HOUSTON AIRPORT SYSTEM

**SUBJECT:** Addendum No. 5

**REFERENCE:** Invitation To Bid (ITB) for the IAH Integrated Coordination Center at George Bush Intercontinental Airport; Solicitation No. H06-IAHICC-2024-004; Project No. 793

MONUMENT SIGN - SINGLE-SIDED

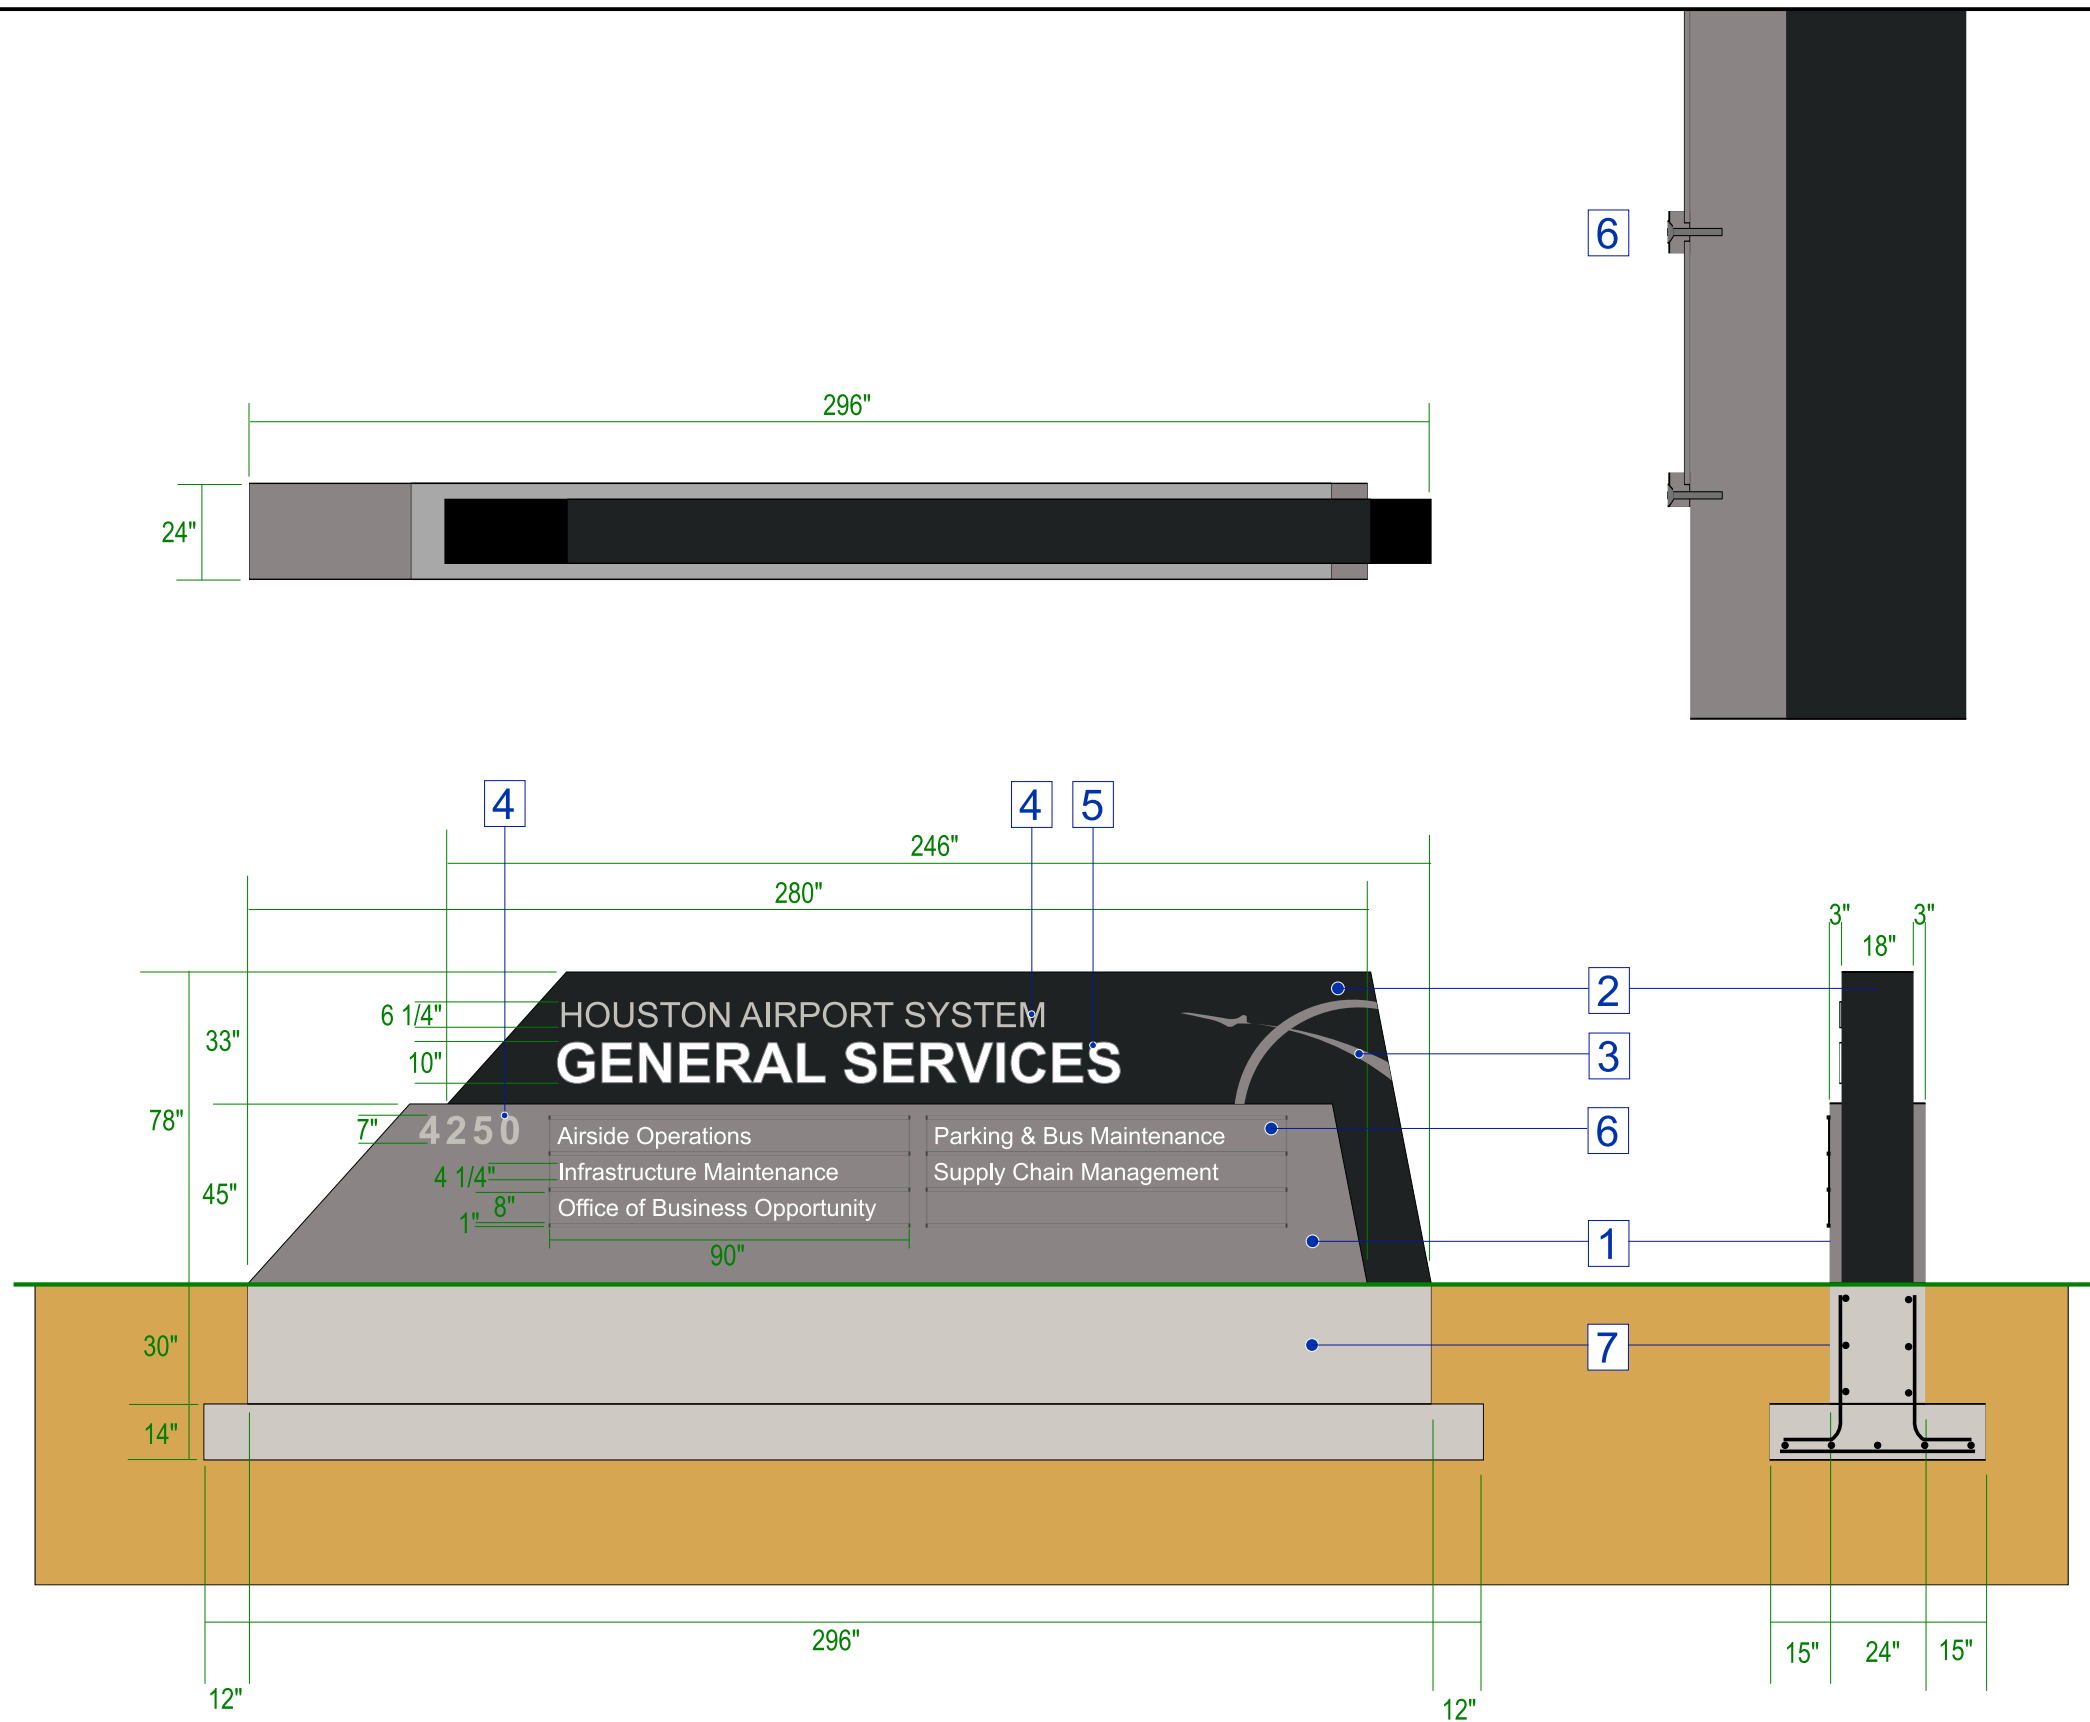
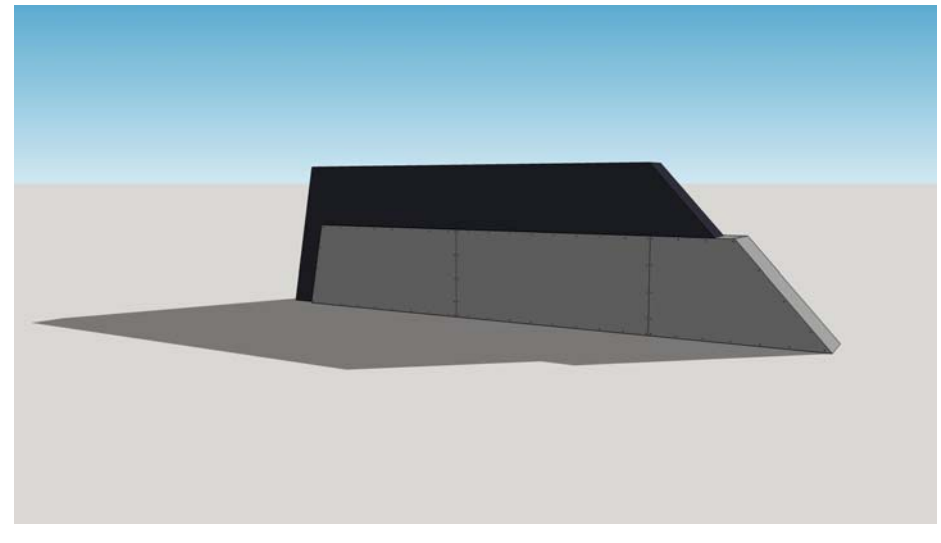
2. **Question:** On page A612 you have to replace letters on the monument wall with others that match. I need to know:
  - a. The height of the other letters
  - b. The depth
  - c. The font
  - d. The color
  - e. The material
  - f. Are they fabricated by routing or are they channel?

g. Do they light up at night?

**Response:** Please see Sheet 10, Sheet 10.1, Sheet 10.2, and Sheet 10.3 attached to this Addendum.

1. BOTTOM COMPARTMENT CONSTRUCTED FROM ALUMINUM INTERIOR FRAME WITH 2" X 2" X 1/4" ANGLES AND COVERED WITH 1/8" THICK ALUMINUM PANEL FACES PAINTED TO MATCH MATTHEWS PAINT MP-28448 "UMBRA GRAY METALLIC".

2. TOP COMPARTMENT CONSTRUCTED FROM ALUMINUM INTERIOR FRAME WITH 2" X 2" X 1/4" ANGLES AND COVERED WITH 1/8" THICK ALUMINUM PANEL FACES PAINTED TO MATCH MATTHEWS PAINT MP-42359 "VINE CHARCOAL".

3. LOGO GRAPHICS PAINTED TO MATCH MATTHEWS PAINT MP-28448 "UMBRA GRAY METALLIC".

4. 1/2" THICK VERTICALLY BRUSHED ALUMINUM CUT LETTERS.  
FONT USED: ARIAL REGULAR & BOLD (ADDRESS)

5. 1/2" THICK ALUMINUM CUT LETTERS PAINTED MATTHEWS WHITE MP-N202.  
FONT USED: ARIAL BOLD
